MAY 18, 2026 REGULAR MEETING

Coastal Development Permit No. 23-073 / 32832 Pacific Coast Highway

A. Coastal Development Permit No. 23-073, Variance No. 25-019, Site Plan Review No. 23-035, and Minor Modification No. 24-005 – An application for the construction of a single-family residence and associated development (Continued from March 16, 2026)

Following the Commission meeting, on April 8, 2026, the applicant submitted revised project plans addressing both requests (Exhibit B). The revised plans include additional dimensions, clarifications, and an updated TDSF General Notes sheet (Sheet A-041) confirming that there are no covered exterior areas six feet or greater in depth; therefore, no square footage has been allotted toward the maximum allowed TDSF differently than what had been represented at the past meeting. The applicant also submitted a View Corridor Memorandum (Exhibit C) documenting the basis for the view corridor location, driveway tree, and frontage vegetation.

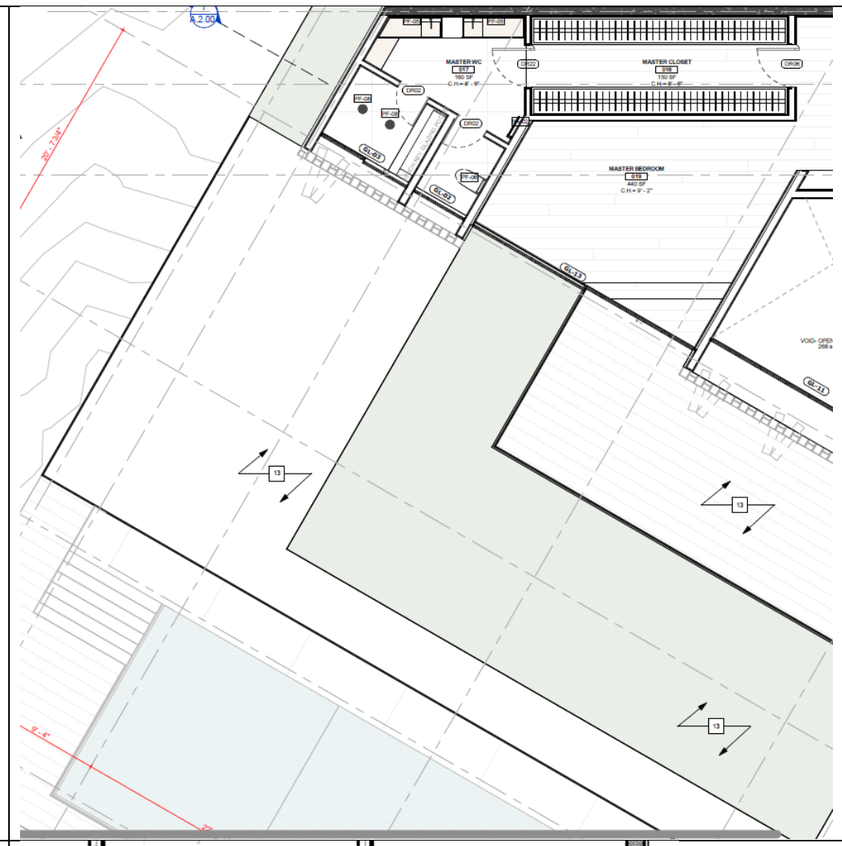
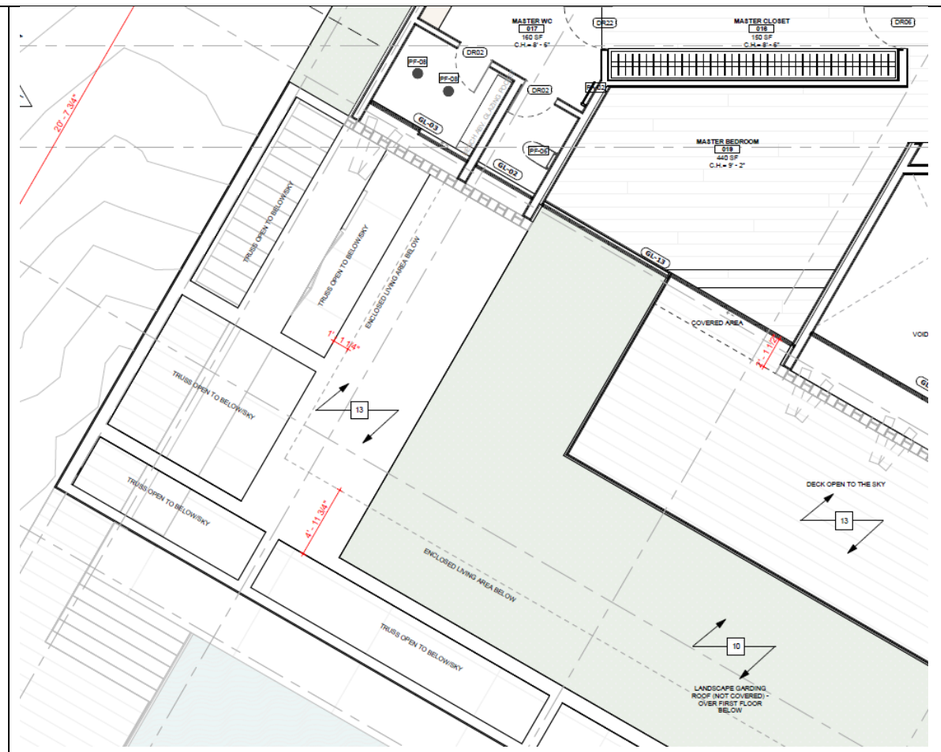
A.1.100			Dimensioned covered area over sink, which is required by EH, and over prep area at 2'-6". Area over the walkway is open truss/pergola- see roof plan.

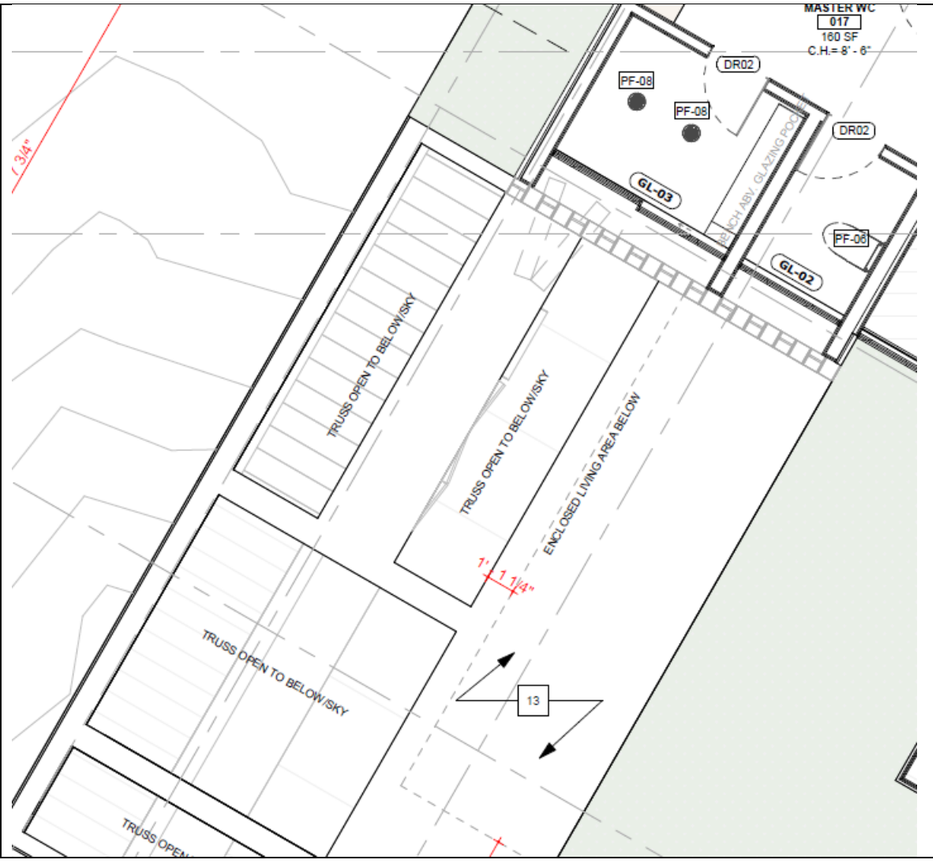
A.1.101			Floor plans have been updated to clarify the proposed open truss/pergola design over exterior areas, the enclosed living area below, and to clearly delineate dimensions of covered areas and areas open to the sky in response to questions regarding conformance with the 6-foot covered area threshold.
A.1.101

A.1.101			
A.1.101			Reduced balcony reflects the reduction of the SFR on the east side. Covered balcony identified as such and dimensioned.

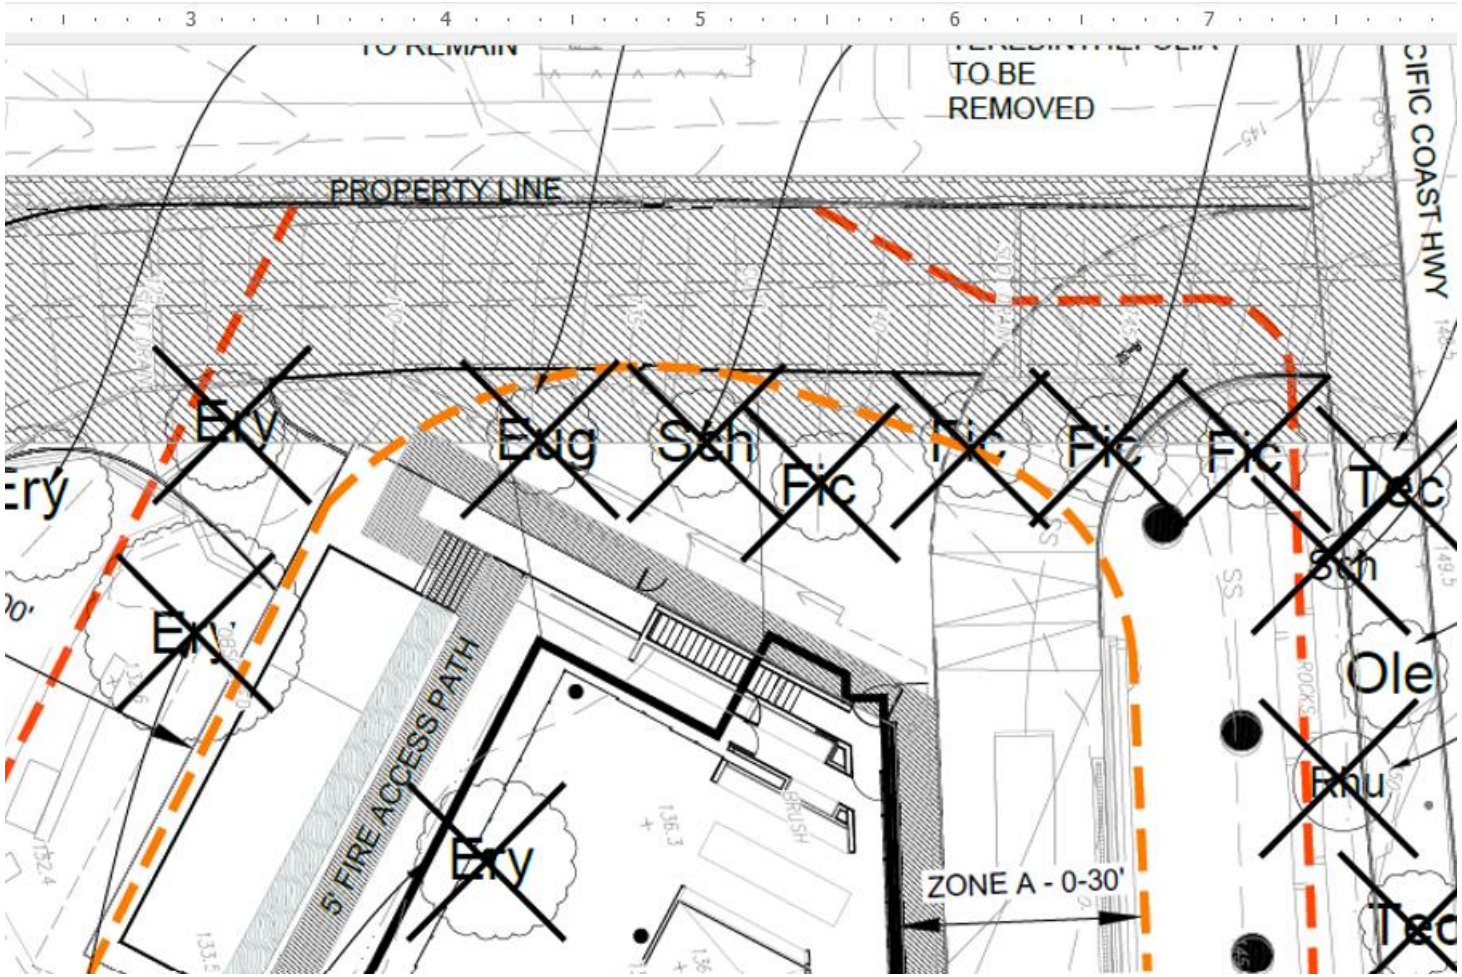
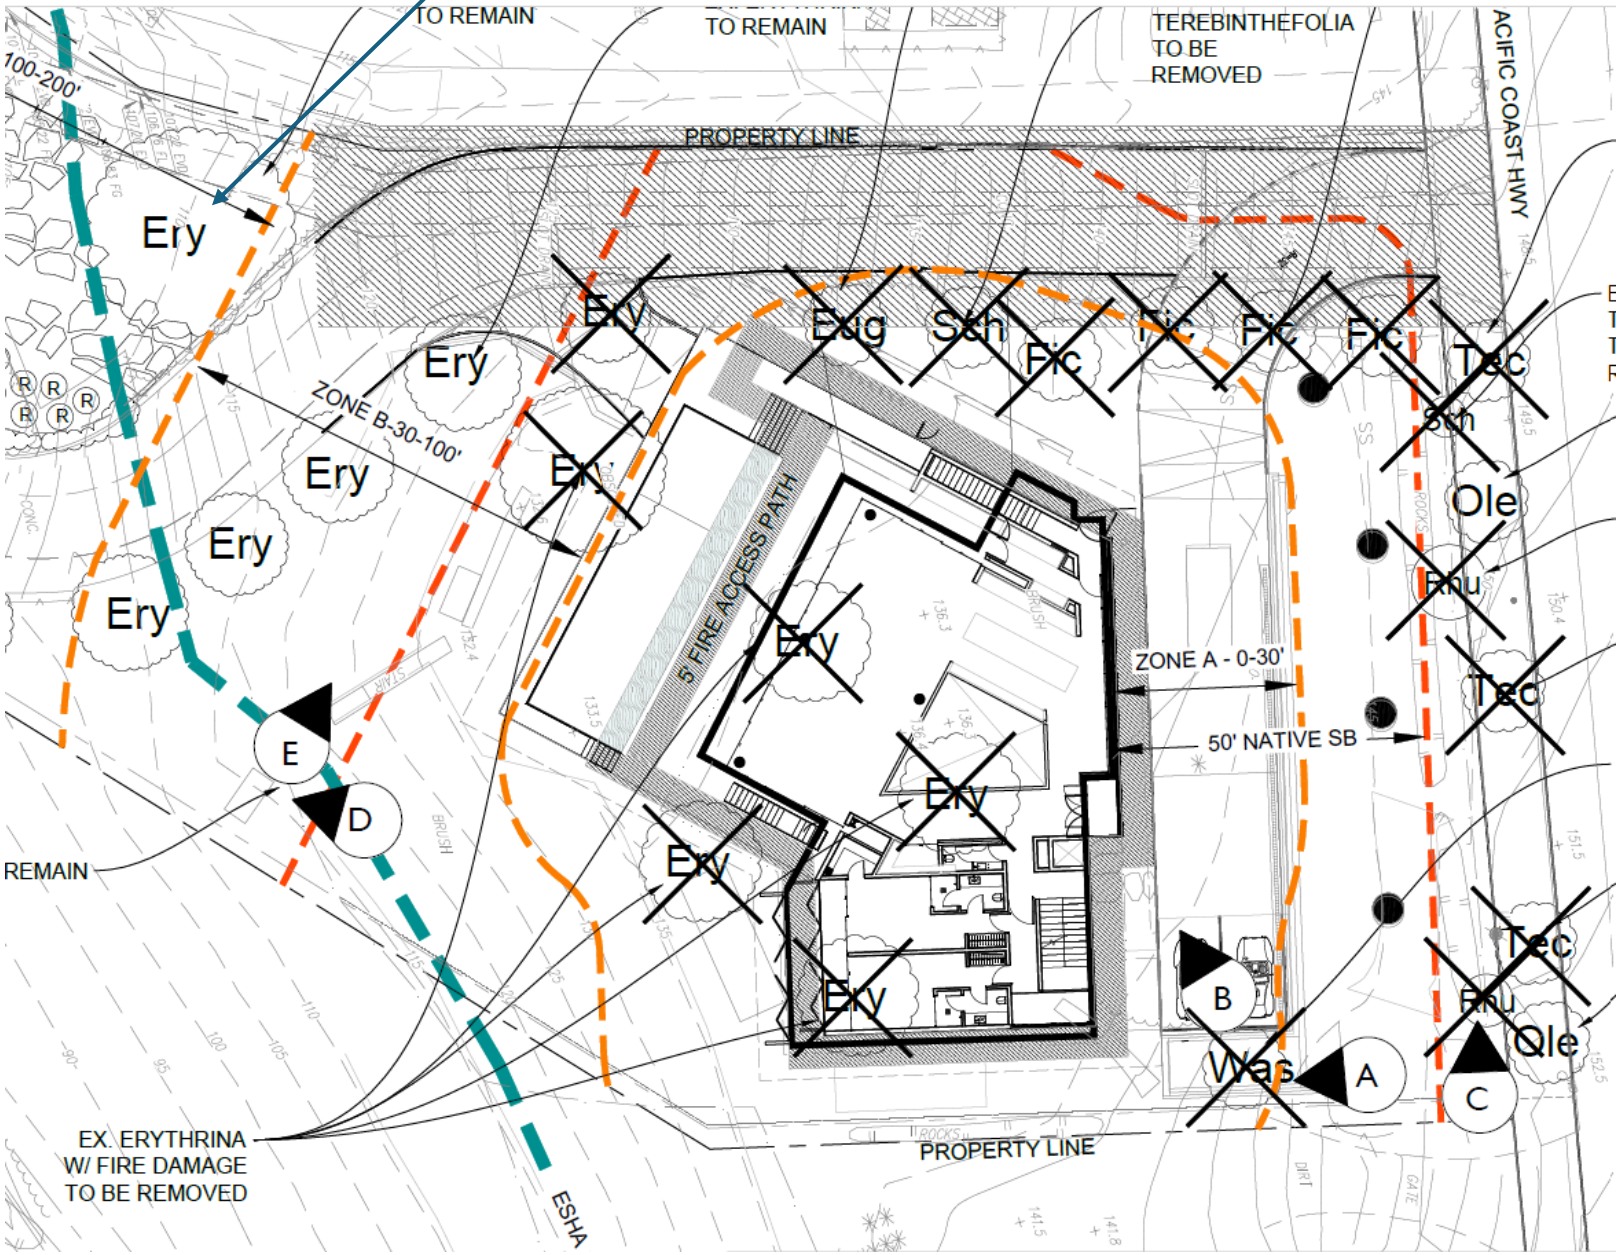
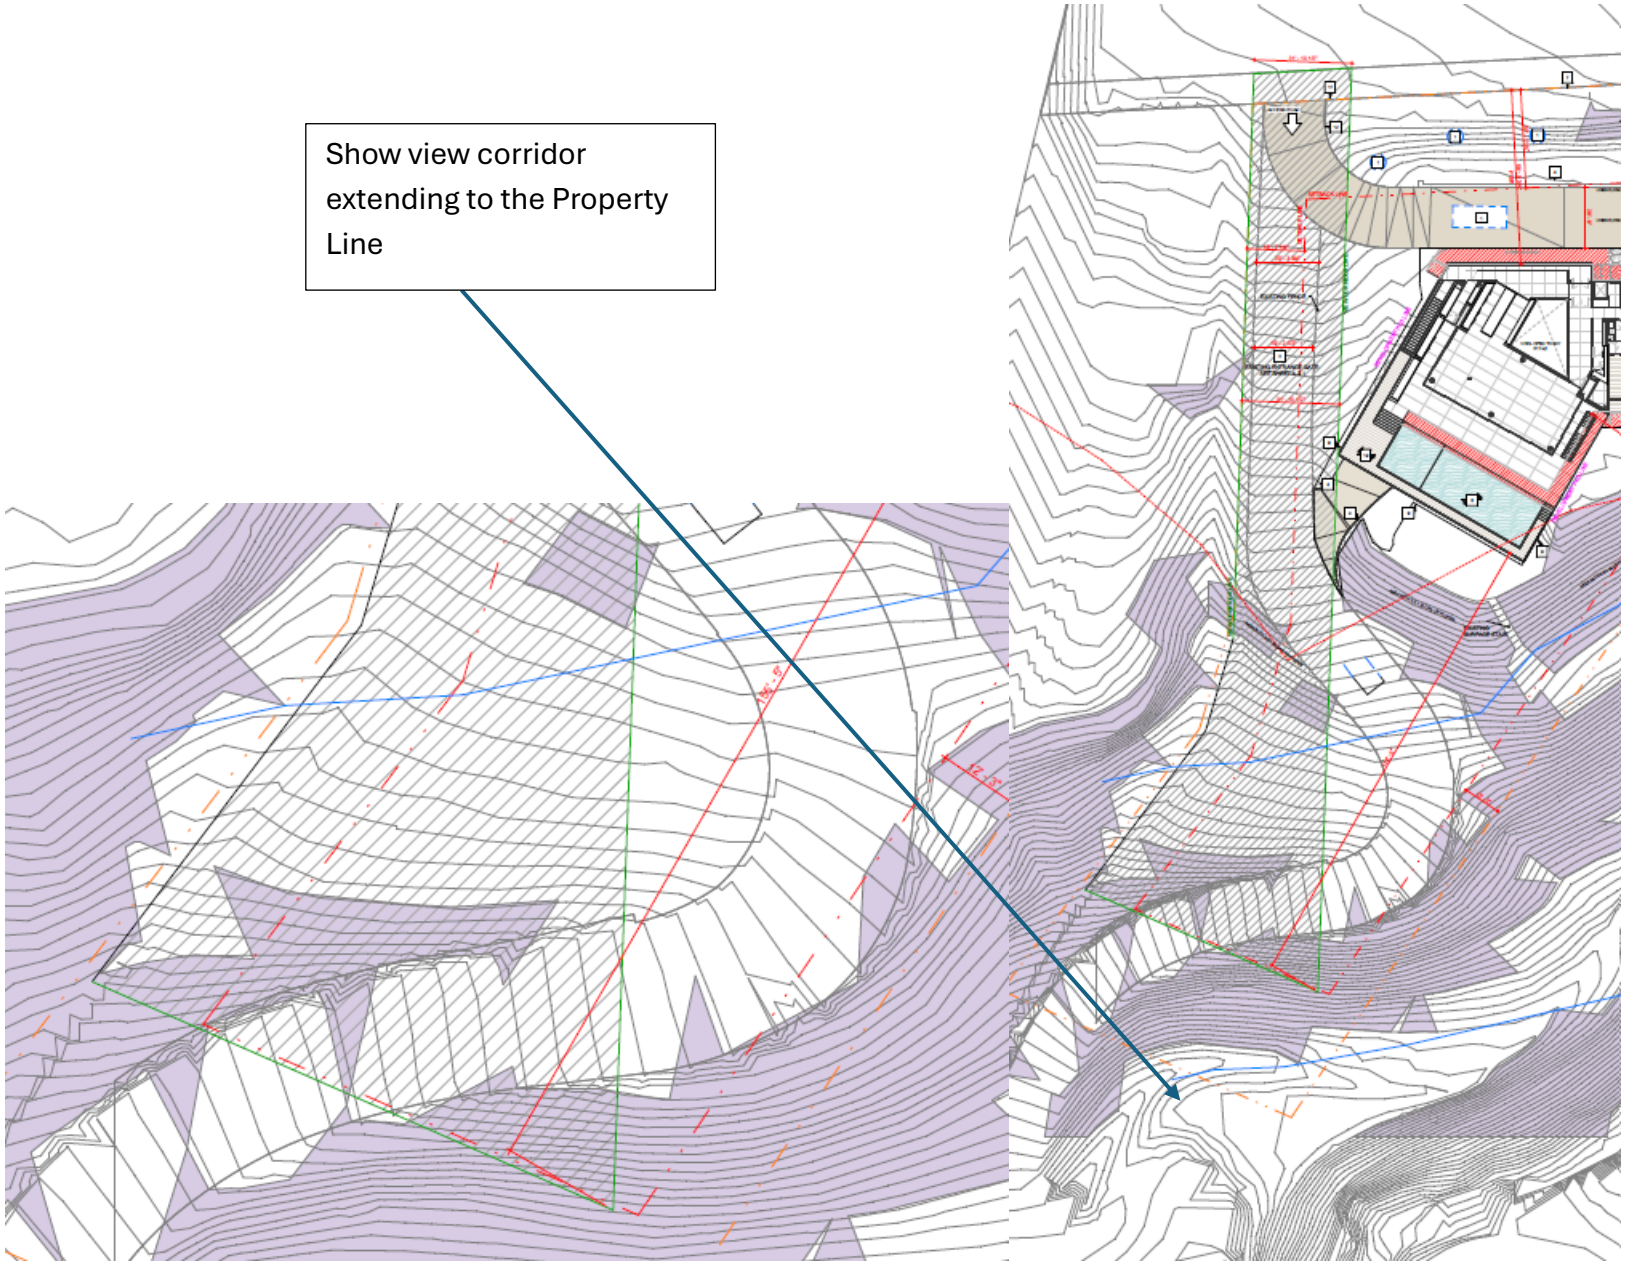
All trees within the proposed view corridor that extend above road grade are proposed to be removed in order to open and preserve ocean views. The site topography drops significantly from PCH, which inherently enhances view opportunities as the parcel descends.

The tree at the bottom of the driveway referenced by the Commission is located on the subject parcel; however, it was installed by the neighboring property owner as part of their entry landscaping. In an effort to maintain good neighbor relations, the owner has sought to retain this tree unless its removal is necessary to achieve compliance.Because the tree is located largely below road grade and is regularly maintained, it does not create a material obstruction to ocean views. To further address this, the owner has proposed a wider view corridor than otherwise required by Code, thereby offsetting the retention of this tree.

Additionally, the project proposes a more expansive view corridor along the ocean-facing portion of the parcel to meet the intent of the view corridor provisions, even though this approach exceeds the strict language of the Code. While the Code contemplates corridors running parallel to property lines, the proposed design extends the line of sight along the length of the parcel to maximize available views.

Proposed view Corridor

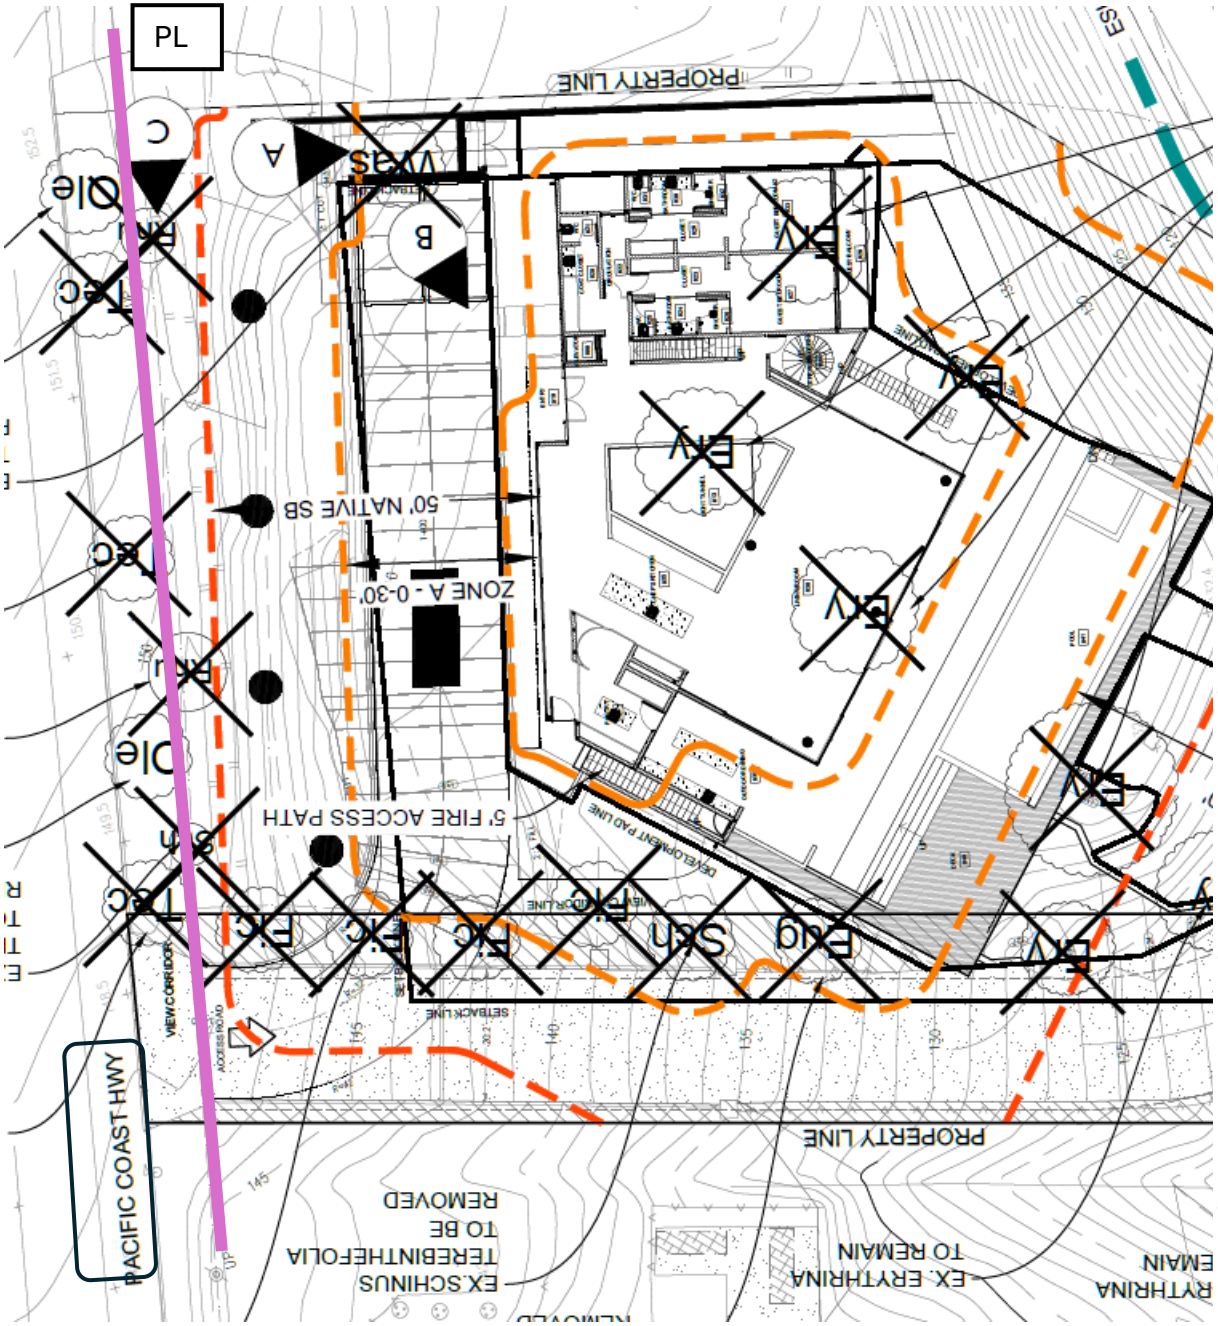
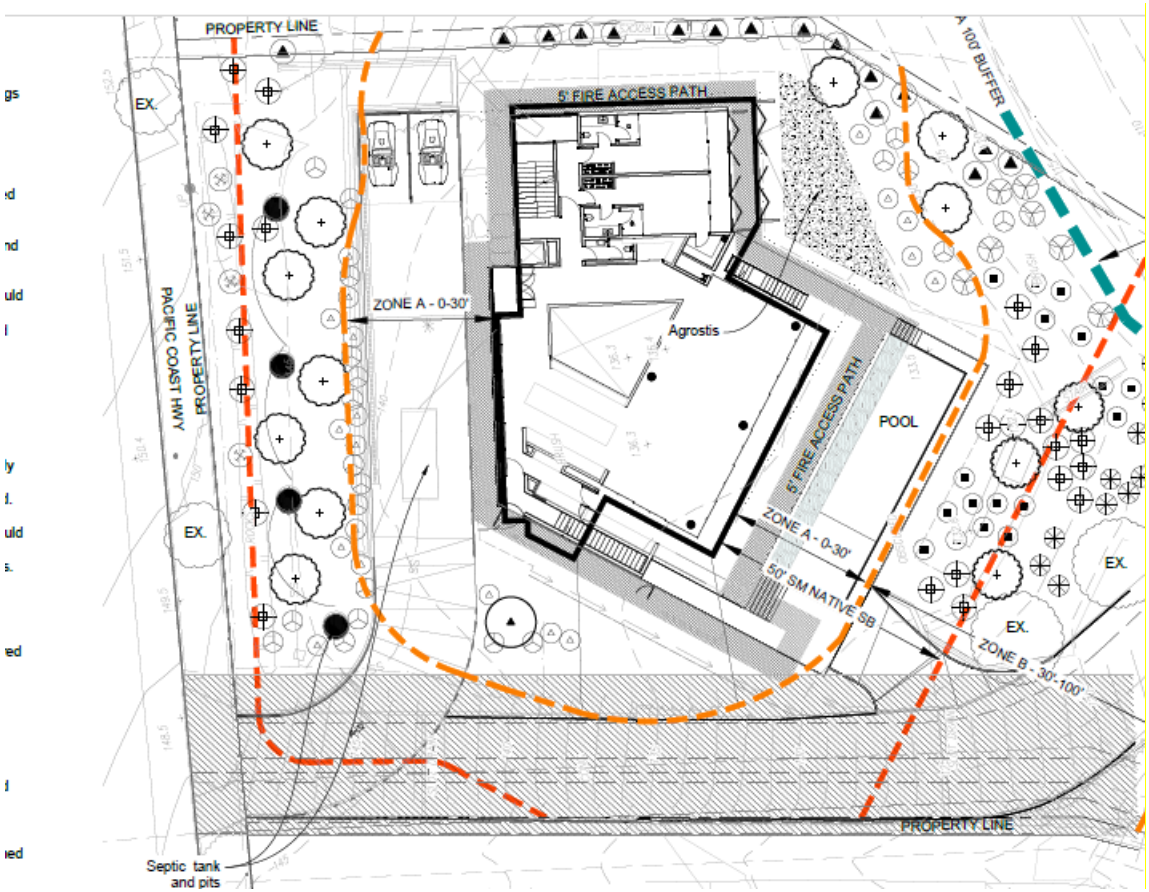
The vegetation on the left side of the purple line (PL) is off-site and within the Caltrans ROW and subject to Caltrans authorization. The owner is proposing to remove the Tecomaria shrubs, which is a fast growing screening shrub. Two fruitless olive trees on either side of the property are proposed to remain.
